**ALABAMA
DEPARTMENT OF TRANSPORTATION**

**Subject: Annual Inspection Report
Prattville Municipal (Grouby Field) Airport**

**ANNUAL INSPECTION REPORT
PRATTVILLE MUNICIPAL (GROUBY FIELD) AIRPORT
PRATTVILLE, ALABAMA**

November 1, 2010

INSPECTION SUMMARY

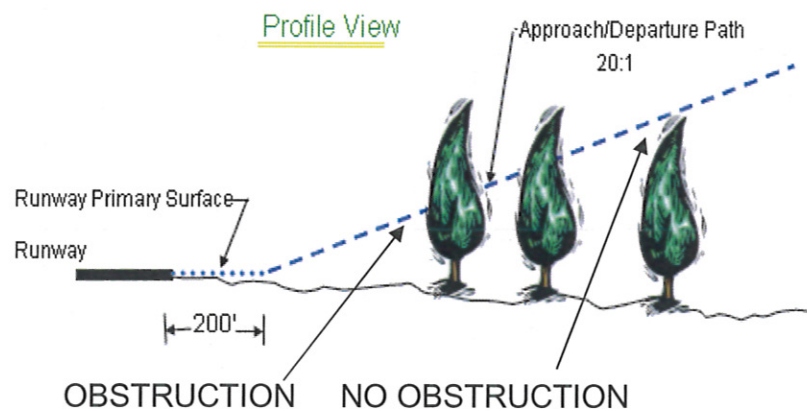
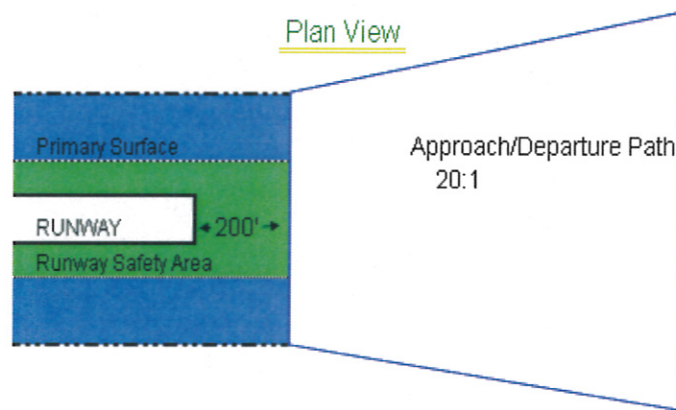
Inspection Area	Violation/Maintenance	Corrective Action
Airport Markings	Maintenance	Remark runway in accordance with FAA AC150/5340-1J "Airport Markings"
Airport Lighting – PAPI unit of Runway 9	Maintenance	1. Adjust visual angle to provide a clear unobstructed path. NOTAM condition.
